ZONING STAFF REPORT
2026-4619-ZC

Location: Parcel located on the north and south sides of West Ochsner Blvd, and west of S. Ochsner Blvd., Covington; S11 & S12, T7S, R10E; Ward 1; District 1

NORD DU LAC COMMERCIAL PARK REGIONAL BUSINESS CENTER OVERLAY

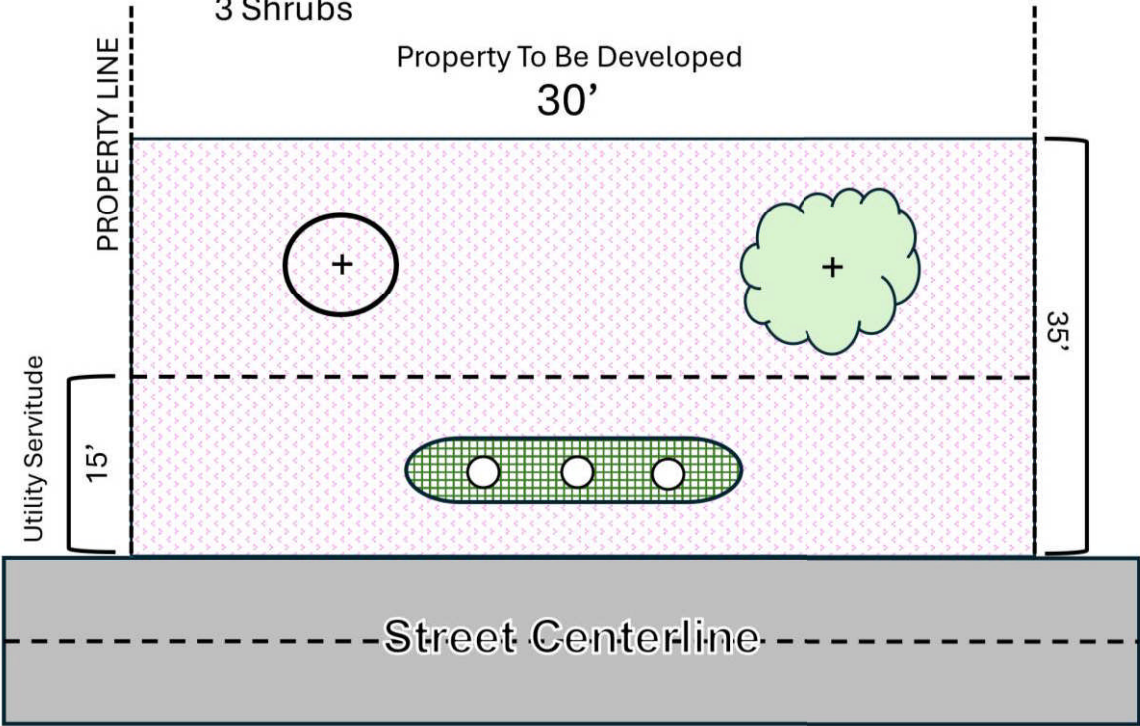
- Y. Street Landscape Buffer Area Chart: Requires 1 Class A tree, 1 Class B tree, and 3 shrubs

Staff Comment: The applicant should revise this to provide a maximum allowable percentage by which a single tree may count toward more than one landscape requirement and remove the verbiage "Mitigation Live Oaks Allowed". This picture should also be revised to reflect that the metric is 1 Class A tree, 1 Class B tree, and 3 shrubs per 100 linear feet, and not in general.
